# Town of Brunswick, Maine

### DRAFT FINDINGS OF FACT REQUEST FOR CERTIFICATE OF APPROPRIATENESS FOR ALTERATIONS VILLAGE REVIEW BOARD

**PROJECT NAME:** 42 Maine Street, New Café/Bistro Façade

**CASE NUMBER:** VRB 25-019

## Proposed North Elevation For Windows & Side Wall

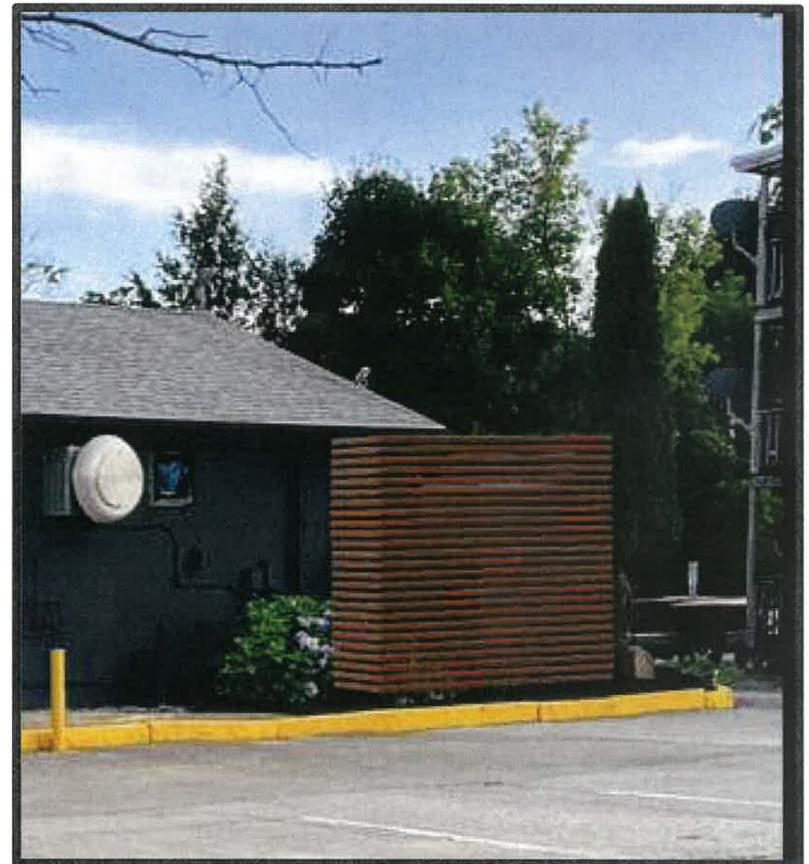
New metal awnings installed on side elevation will be fastened to the cinder block wall above each window to not impact underlying brick material.

The proposed awnings on the north facade are a weatherproof material (metal) and do not appear to overwhelm the building façade given the impact will be limited to above three windows. The applicant also proposes to retain the existing retractable cloth awning.

## 5 FT. – HOUSTONIAN® AWNING

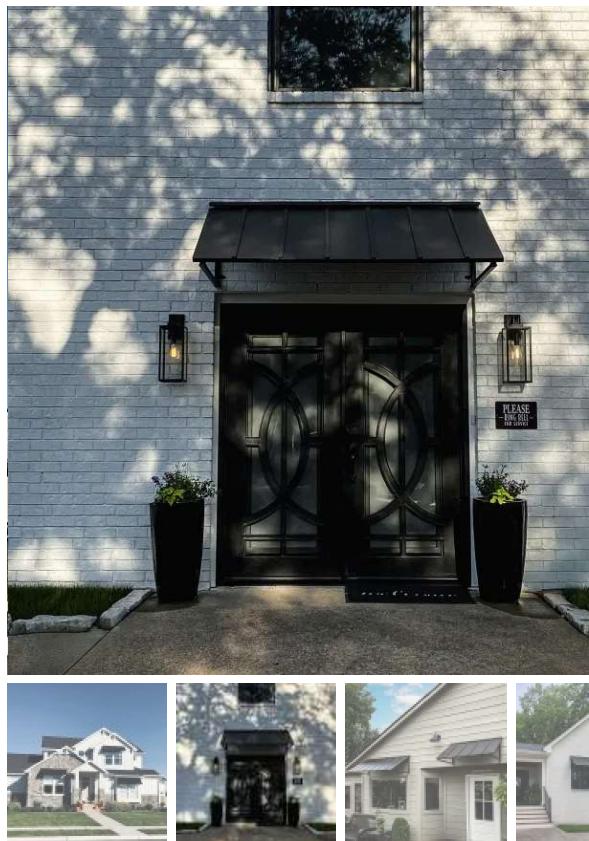
An example of the metal awnings has been submitted to document the intended appearance. A similar metal awning can be seen at the Sotheby's building at 141 Maine Street.
